**NOTICE OF ADDENDUM**  
**ADDENDUM NO. 3**

**CONTRACT NO. 7951**  
**Capitol East District Parking Structure**

This addendum is issued to modify, explain or correct the original Drawings, Specifications, or Contract Documents of the subject contract and is hereby made a part of the contract documents.

**BIOFILTRATION BASIN**  
N.T.S.

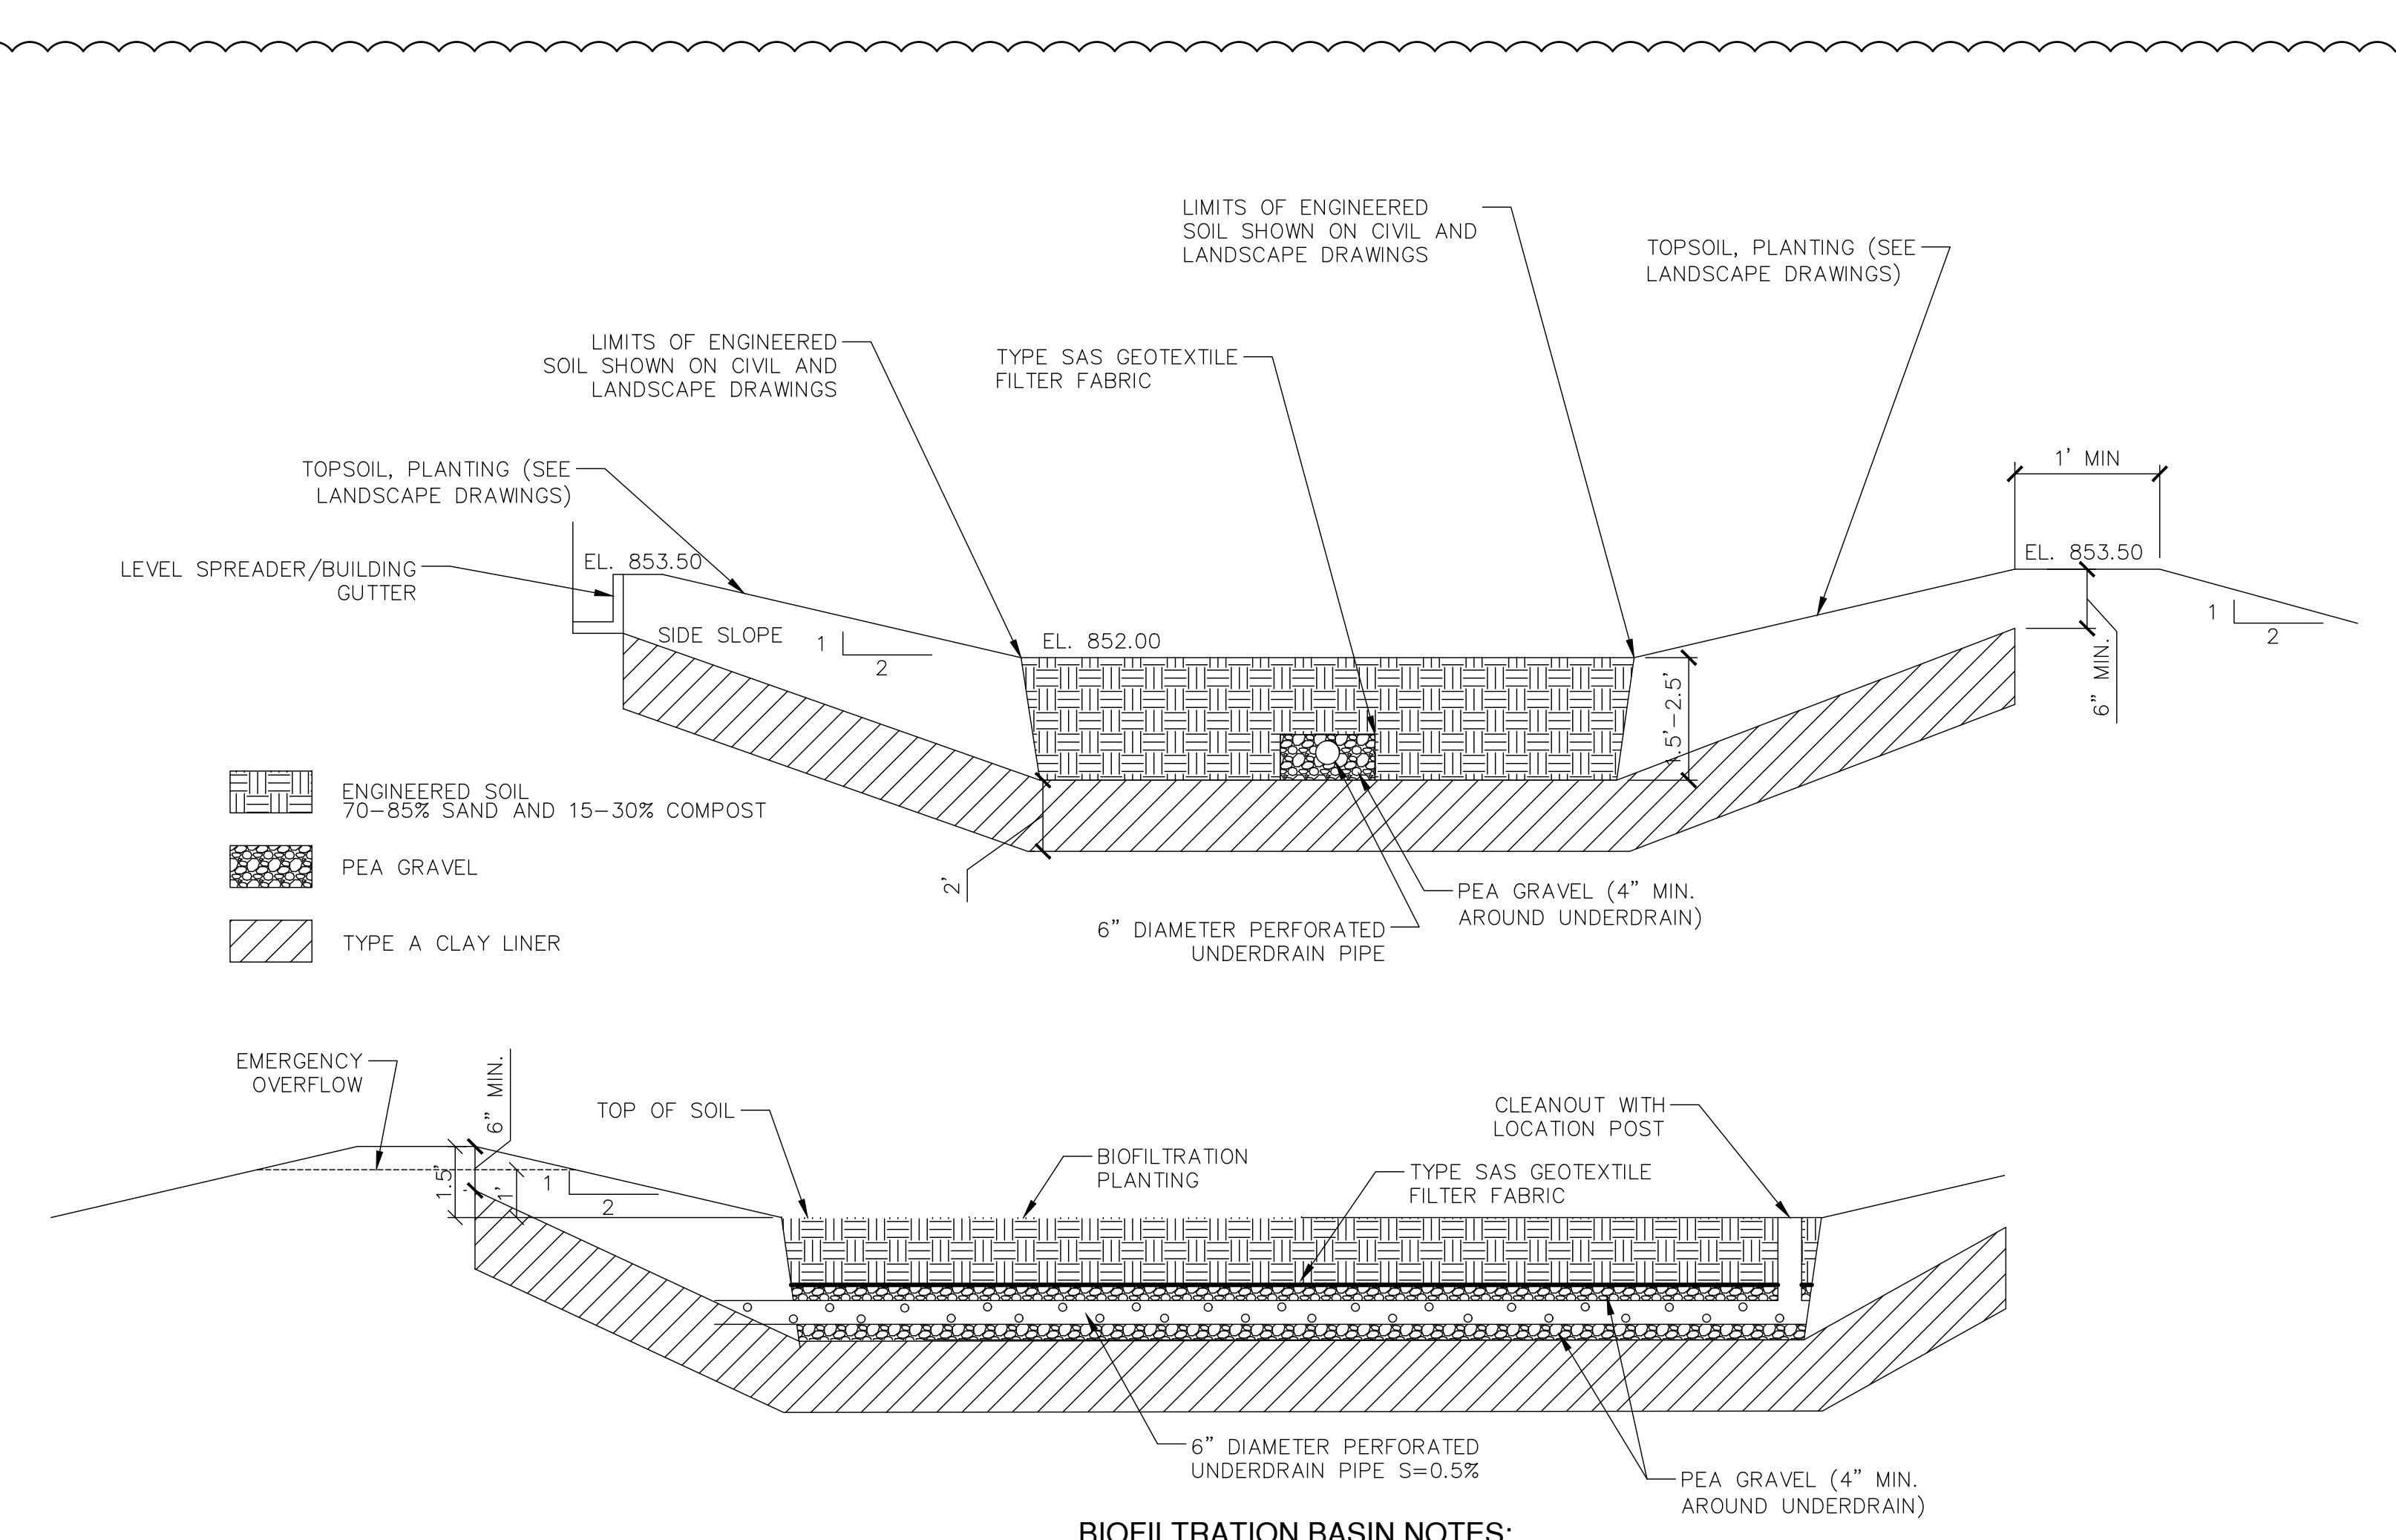
- A. C-201-204 – Site Detail Plans (Reissued)
  - i. Building setback dimensions added
- B. C-900 – Construction Details (Reissued)
  - i. Clay liner added to biofiltration basin detail A5

### B1 FIRST LEVEL PARKING - FIRST FLOOR COMMERCIAL PLAN

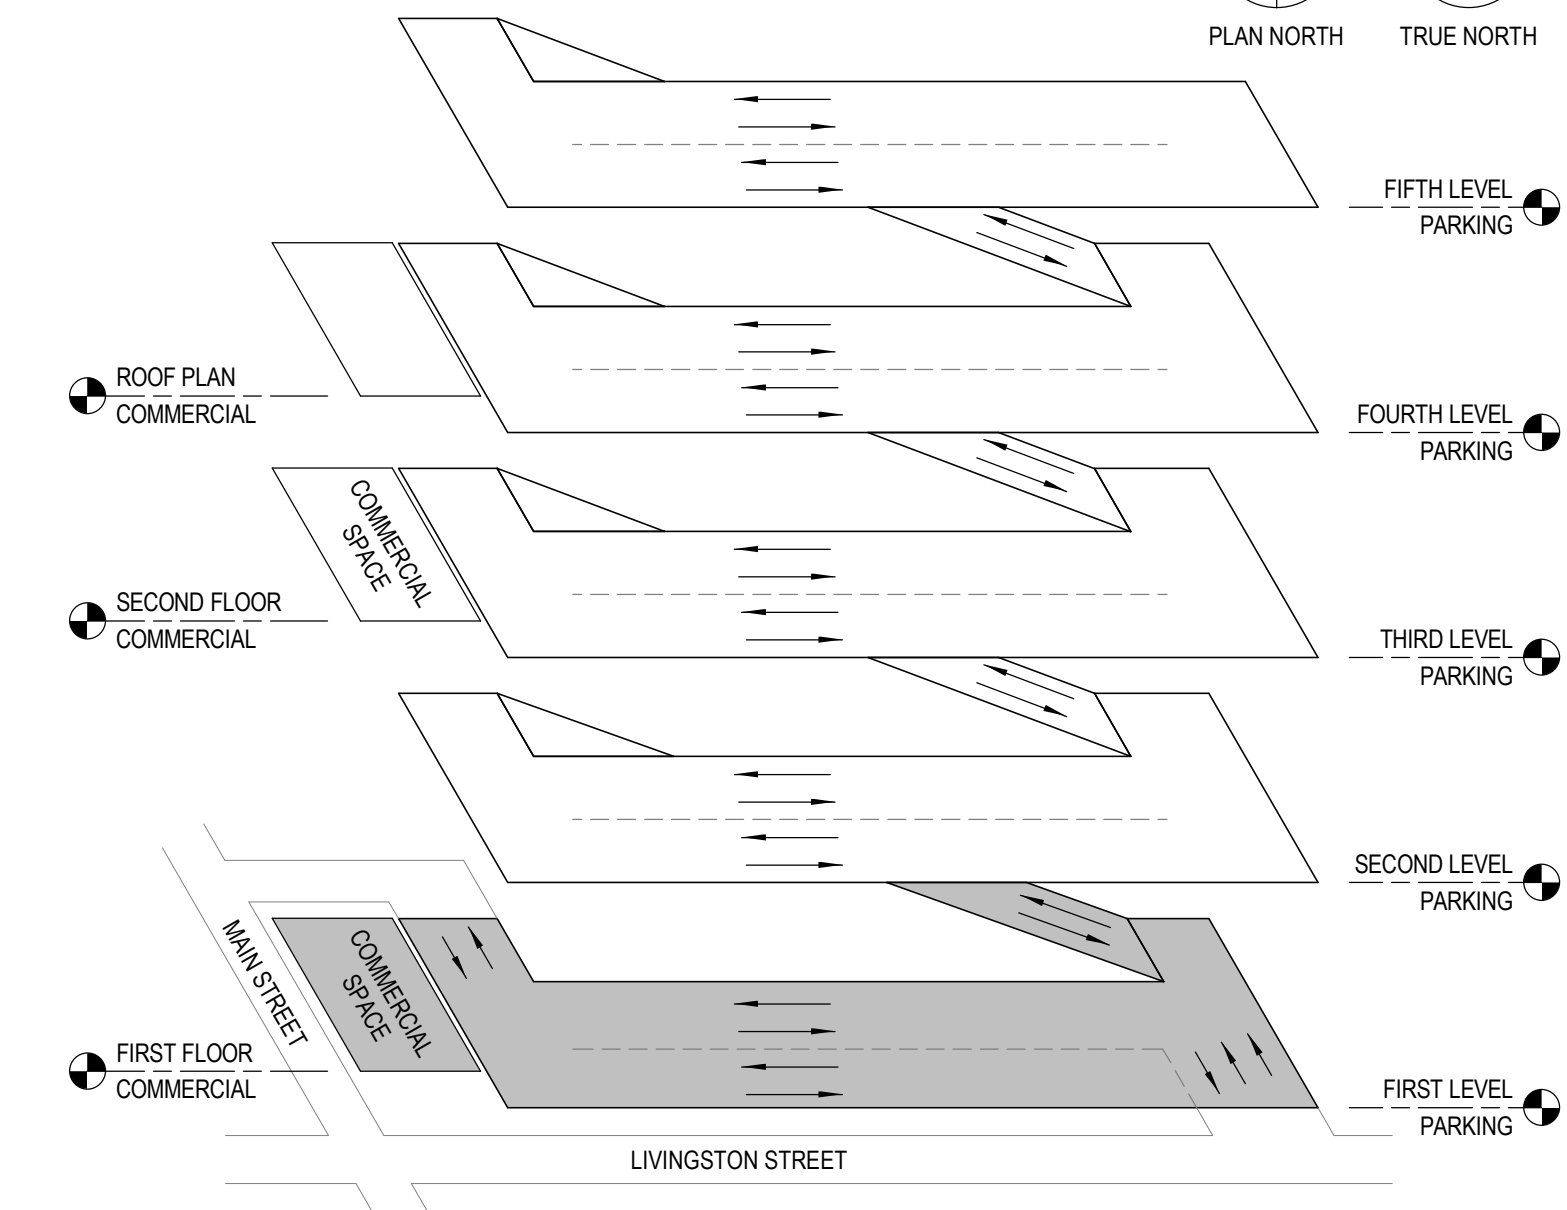
- A. S-002 – General Notes (Reissued)
  - ii. Modify property line on loading diagram.
- B. S-101 – First Level Parking – First Floor Commercial Plan (Reissued)
  - iii. Add conduit/pipe detail call out and keynote to column location.
- C. S-102 – Second Level Parking Plan (Reissued)

**E7 PIPE/CONDUIT PROTECTION**  
1" = 1'-0"

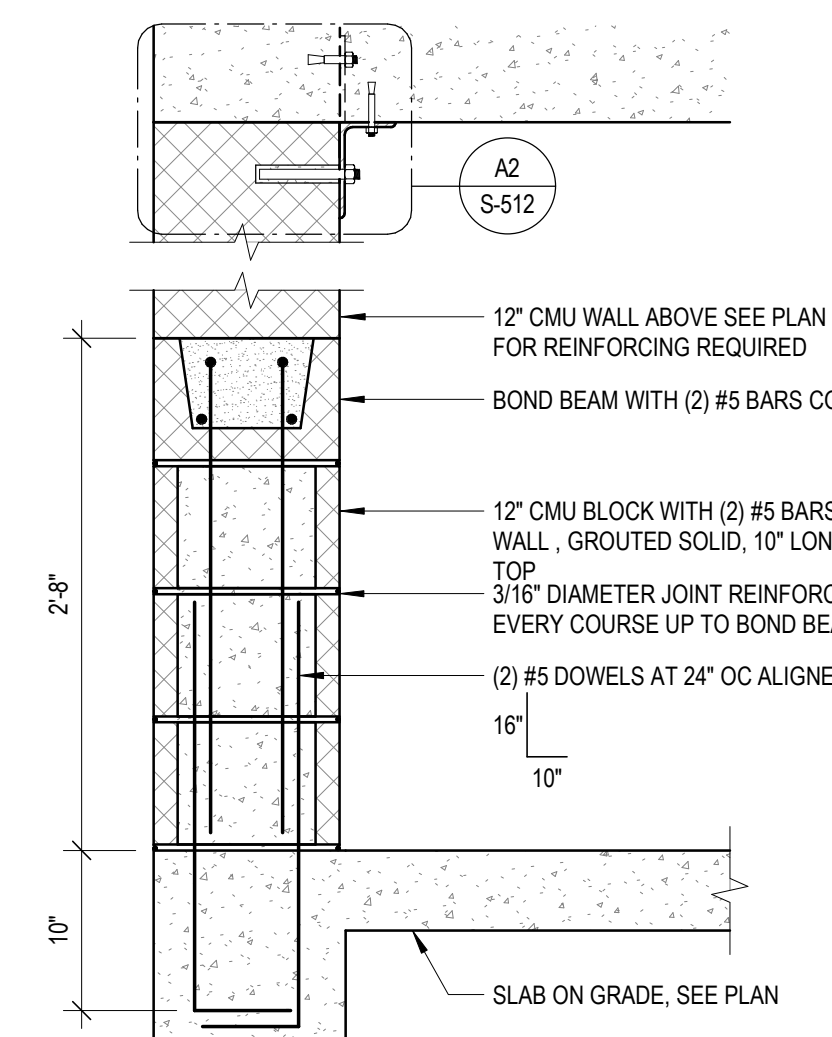
Q35: Are all the ¼" galvanized pipe protectors provided by the GC see detail P-501 B4

**A35: Galvanized protectors are by GC and shown on the structural drawings.**

**B1** THIRD LEVEL PARKING - ELECTRICAL PLAN  
1/8" = 1'-0"

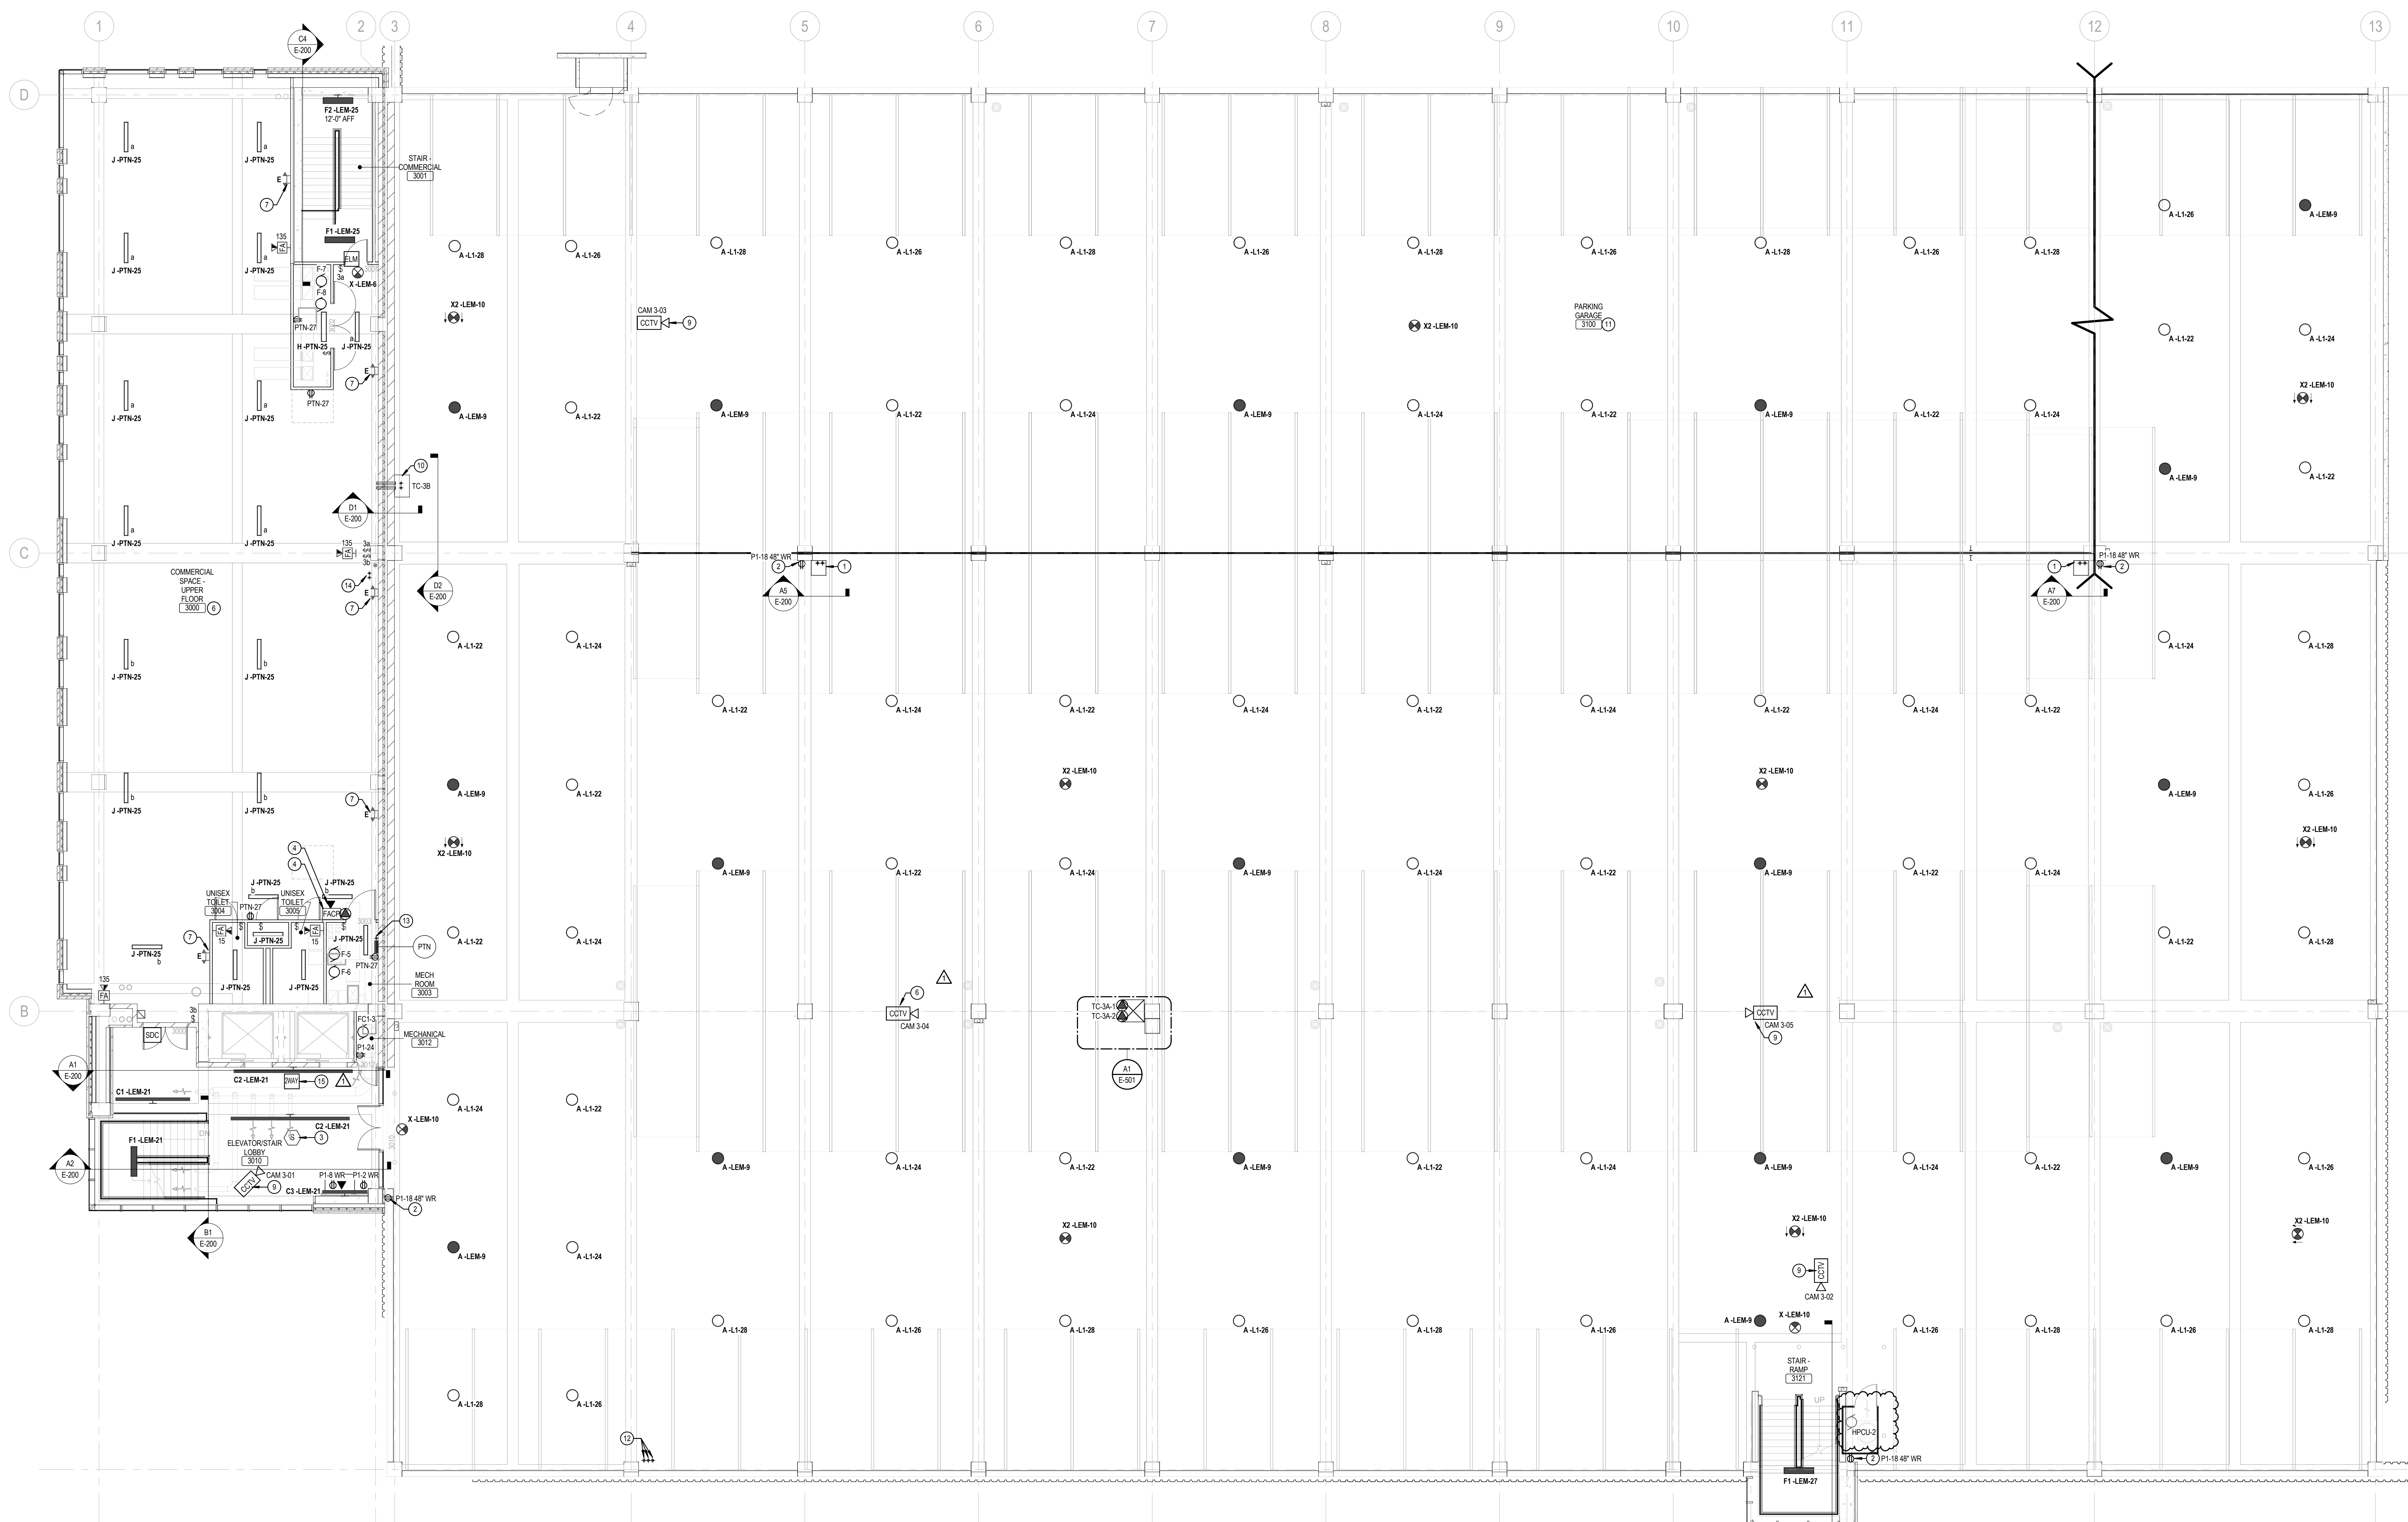
Q39: Sheet E-103 has a note 14 shown by some conduits on the plan North side of the ramp. Keyed note schedule on the sheet does not have note 14, please advise.

**A39: Note #14 will be added to Sheet E-103 in Addendum #3. "Provide (2) 3" conduit sleeves in deck for future service feeds to second floor commercial spaces. Contractor to coordinate sleeve locations with all trades."**
